**E4419B-18A**

# S E R V I C E N O T E

## Agilent E4419B EPM Average Power Meter

### Front Panel Display Problems Caused by Power Assembly Cable

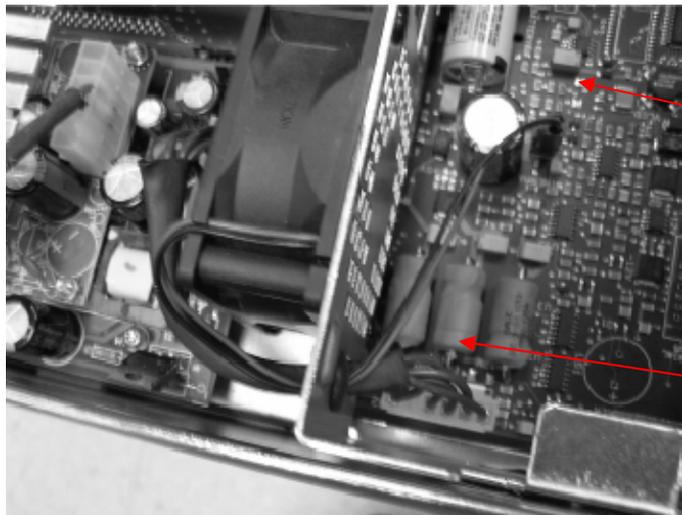
- 3) Remove fan connector and PSU cable assembly.

Fan connector

PSU cable assembly, E4418-61029

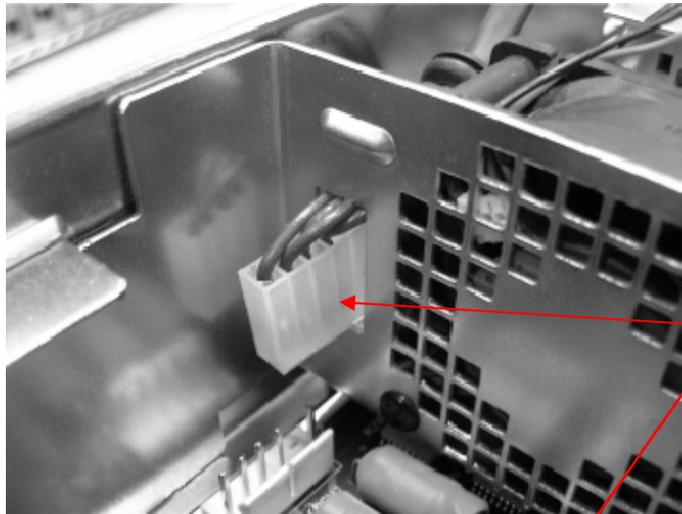
- 4) Replace with new PSU cable assembly E4418-61029. You can differentiate the cable assembly by the colors. The old cable is Black and new cable is RED.

Put back fan connector

New cable with RED color

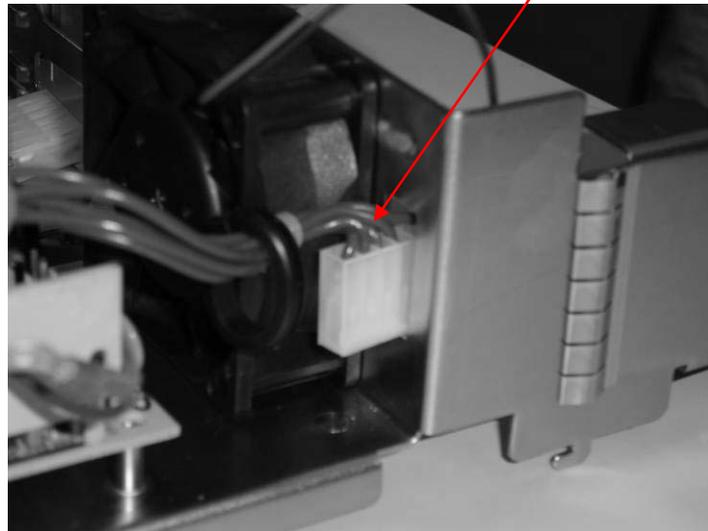
- 5) Here are some tips regarding the new cable. Since the plastic casing is slightly bigger in size, so you cannot directly pass through connector through hole. So you need to insert the cable horizontally. See illustration below.

Insert the plastic casing horizontally

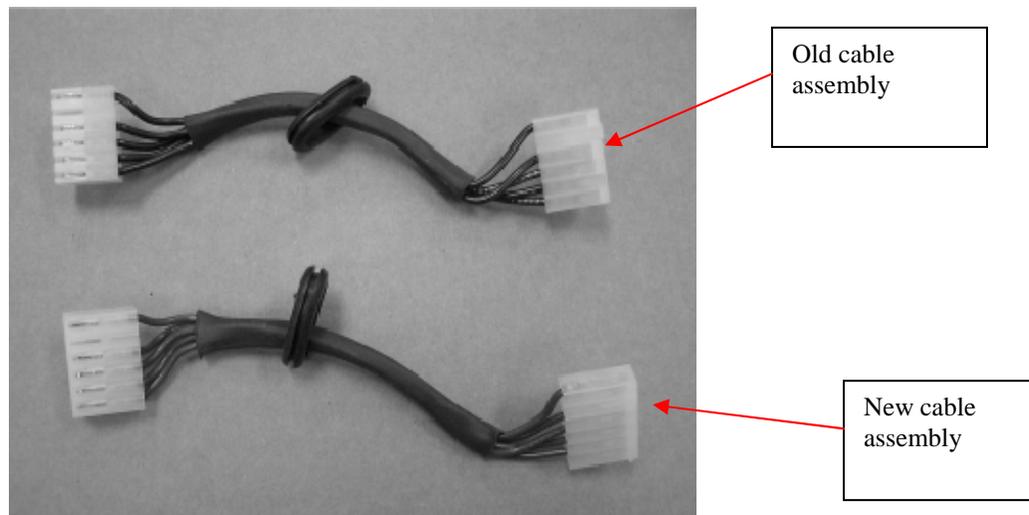
- 6) Photo below show different of old and new cable. The new cable is red in color whereas the old cable is black in color.

Note: If the power cable assembly is red in color, indicates that the cable already been changed. No action is needed.
